Clarifications and Corrections in Response to Supplemental Comments from USEPA Region II BTAG to August 2010 Version of the Koppers Pond ERAGS Steps 3-5 Report

The U.S. Environmental Protection Agency (USEPA) Region II Biological Technical Assistance Group (BTAG) provided supplemental comments to the "Ecological Risk Assessment Steps 3 Through 5 Koppers Pond," dated August 10, 2010 and prepared by Integral Consulting, Inc. for the Kentucky Avenue Wellfield Site, OU 4 located in Horseheads, New York. These comments included input from the U.S. Fish and Wildlife Service.

Figure 3-1. Conceptual Site Model for Koppers Pond and Outlet Channels
Kentucky Avenue Wellfield OU4 - Koppers Pond, Horseheads, NY

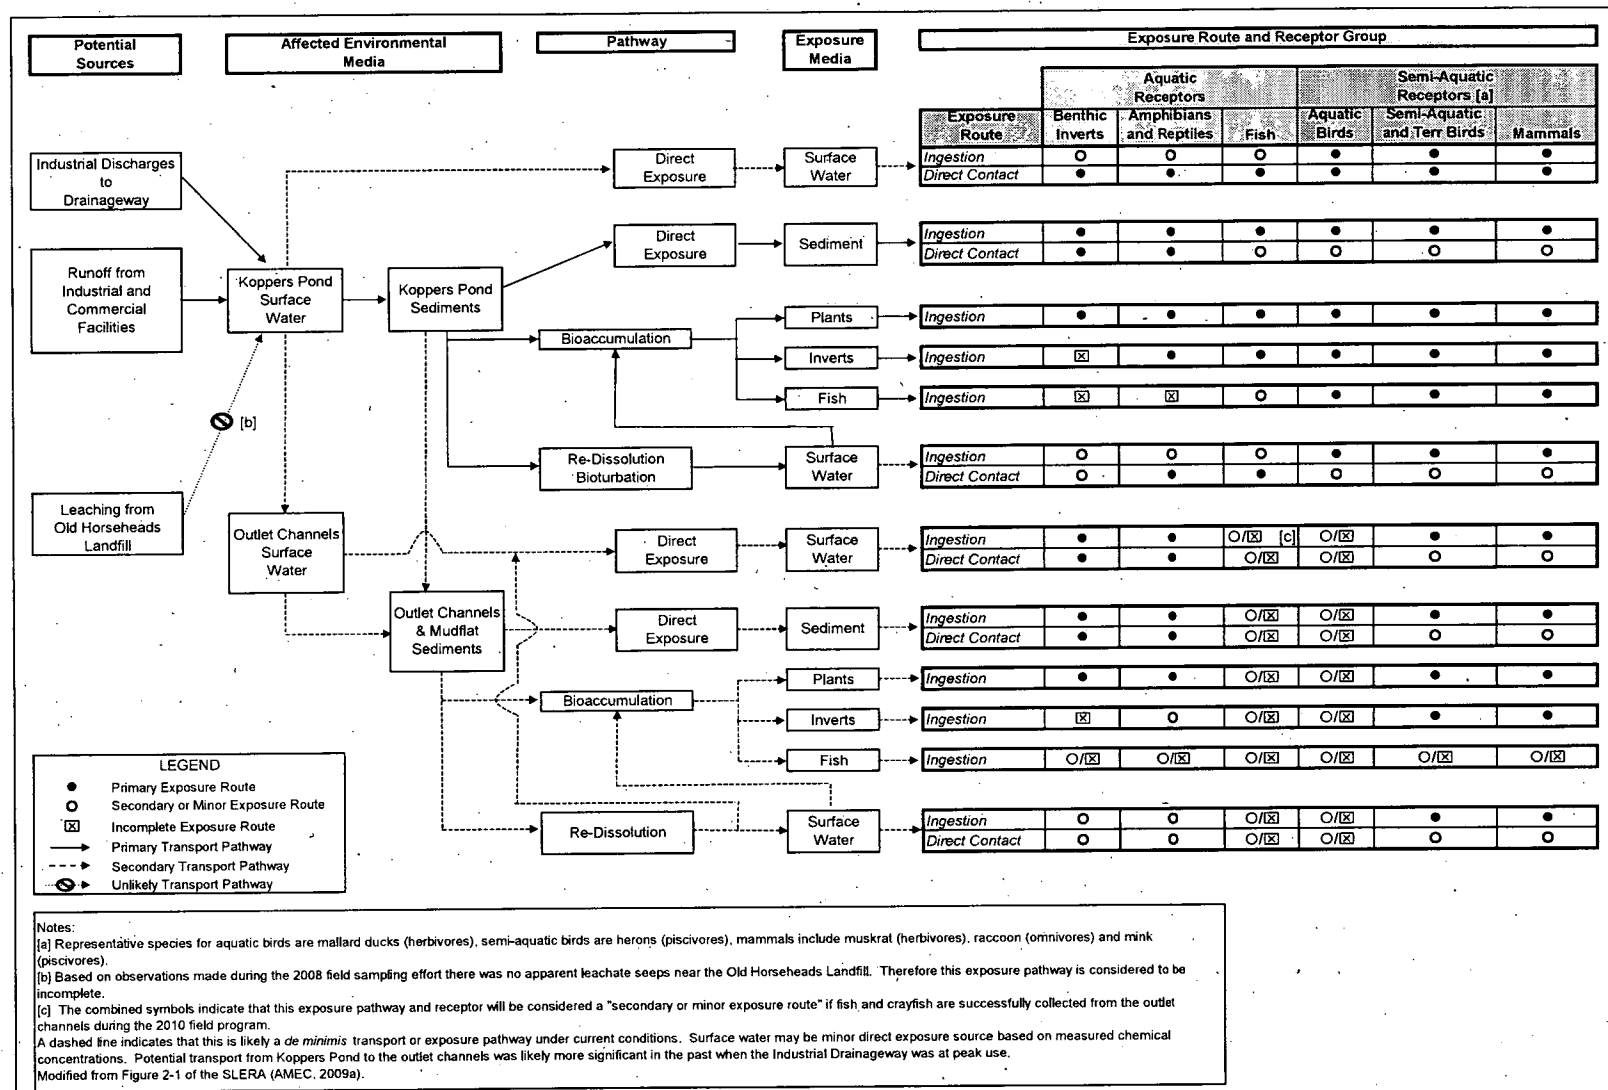
6. Figure 3-1 Conceptual Site Model for Koppers Pond and Outlet Channels: It is unclear why the exposure route is different for the direct exposure "surface water" and the re-dissolution bioturbation "surface water." Please clarify.

7. Section 3.2 Developing A Refined Conceptual Site Model, page 3-10 and Figure 3-1: As discussed in the May 11, 2010 BTAG memorandum, it is unclear why the outlet channels and mudflat sediments are considered incomplete exposure pathways. This area may be considered habitat for amphibians, avian piscivores, avian herbivores, and herbivorous and omnivorous mammals. Further, these channels may also be appropriate habitat for invertivore. Information should be included regarding what receptors will be using this area. Section 2.2.5, Wildlife, notes that "Unidentified minnow-sized fish have been observed in the outlet streams, but not during the 2008 field investigation" and Section 3.5 Selecting Representative Receptors To Be Evaluated In The ERA notes that "semi-aquatic (e.g. amphibians, avian piscivores) and aquatic (e.g. fish) receptors will be evaluated that have a propensity to inhabit Koppers Pond and the outlet streams."

- Further, the discussion of plant collection in Section 4.1.3 Collection of Additional Biota Samples (pages 4-5 - 4-6) notes the presence of grass/leafy vegetation which could be used as "forage for some of the evaluated receptors." Therefore it is appropriate to consider the outlet channels and mudflat sediments as exposure pathways.

- We concur with this comment. A dashed line has been added to the CSM from the bioturbation pathway to the direct contact line. The CSM was also modified to change the "incomplete exposure pathway" symbols to "secondary or minor exposure pathway" symbols to reflect the potential exposure route if fish or crayfish are collected during the 2010 field effort. The updated CSM has been attached, as requested by USEPA during our 29 September 2010 conference call.

- We concur with this comment. We agree that the outlet channel can include some of the receptors that will be evaluated in the supplemental BERA (e.g., amphibians). However, most of the area is well-vegetated and the outlets are fairly shallow, so they do not represent ideal forage habitat for avian receptors - although these species may traverse these areas (e.g., herons).

The updated CSM has been attached, as requested by USEPA during our 29 September 2010 conference call.
